ATTACHMENT C  
SONGS UNIT 2  
PROPOSED TECHNICAL SPECIFICATIONS

ATTACHMENT D  
SONGS UNIT 3  
PROPOSED TECHNICAL SPECIFICATIONS

ATTACHMENT E  
SONGS UNITS 2 AND 3  
FIGURES

ATTACHMENT H  
SONGS UNITS 2 AND 3  
PLANT PROTECTION SYSTEM SETPOINT EVALUATION

Figure H-1

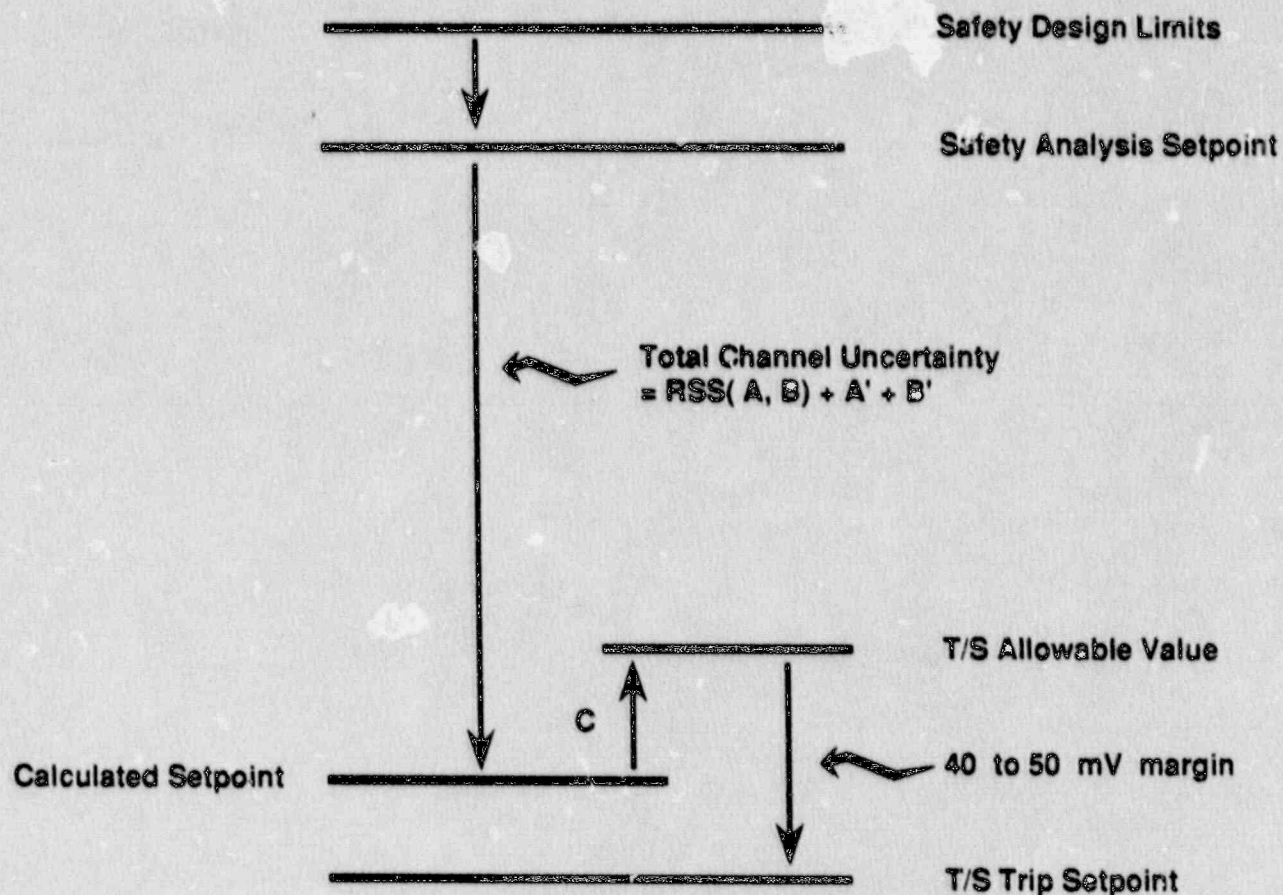
- a) The Low Pressurizer Pressure trip setpoint calculation was revised to reflect more realistic containment environmental conditions for both small and large break LOCA environments, an increased value for transmitter drift and an increased tolerance for PPS bistable functional testing.

The Low Pressurizer Pressure actuation setpoint was recalculated with reduced total channel errors for both large and small break LOCA. Channel errors for containment pressure and temperature, which are inputs in the setpoint calculations, were revised from 60 psig and 350 degrees F to 5 psig and 250 degrees F, respectively. High Containment Pressure ESFAS trip and SIAS functions are credited in limiting containment temperature to less than 250 degrees F and containment pressure to less than 5 PSIG in considering the worst case environmental errors for Low Pressurizer Pressure SIAS initiation. The calculation for Low Pressurizer Pressure resulted in a lower actuation setpoint of 1740 psia in place of the existing 1806 psia.

- b) The High Containment Pressure trip setpoint calculation was revised to reflect the increased Safety Analysis Setpoint, increased value for transmitter drift and an increased tolerance for PPS bistable functional testing.

The High Containment Pressure actuation setpoint was revised from 2.95 psig to 3.4 psig. The associated Safety Analysis Setpoint was increased from 4.0 to 5.0 psig. LOCA analyses do not explicitly credit reactor trip or SIAS on high containment pressure. High containment pressure trip is credited in limiting containment temperature to less than 250 degrees F prior to initiation of a SIAS function. This change in setpoints was evaluated with regard to this criteria, and it was determined that containment temperature will not exceed 250 degrees F prior to containment pressure exceeding 5 psig. The changes in the limiting containment environmental conditions are described in paragraph a) above.

- c) The Low Steam Generator Water Level actuation setpoint recalculation was revised to reflect a revised Safety Analysis Setpoint, increased value for transmitter drift, a more realistic value for worst case reference leg temperature and an increased tolerance for PPS trip bistable functional testing.

- d) The Low Steam Generator Pressure actuation setpoint was calculated based on the increased sensor drift and an increased tolerance for PPS bistable functional testing. No change to the existing Safety Analysis Setpoint was required.
- e) The Containment Pressure Hi-Hi actuation setpoint was calculated based on the increased sensor drift and an increased tolerance for PPS bistable functional testing. No change to the Safety Analysis Setpoint was required.
- f) The High Steam Generator Delta Pressure actuation setpoint was calculated based on the revised sensor drift and an increased

tolerance for PPS bistable functional testing. The actuation setpoint was revised from 50 psid to 125 psid. The associated Safety Analysis Setpoint was increased from 100 psid to 250 psid to allow for more room between the equipment setpoint and the normal variation in delta pressure. C-E reanalyzed the limiting decreased heat removal event (feedwater line break) to demonstrate that the pressurizer will not be filled solid due to the revised setpoint and that the feedwater line break results are bounded by the analysis presented in FSAR Section 15.2.

The results of the C-E calculations are shown in Table H-1 along with the existing Technical Specification setpoints and allowable values for the ESFAS setpoints. A number of the new setpoint values provide more operating margin than the existing values while still based on the same accident analysis limits. Safety Analysis Setpoints (described in Section 4.2) have been revised in some cases (where indicated below) to provide more operating margin and to reduce the potential for spurious ESF actuation, while still based on the same accident analysis limits.
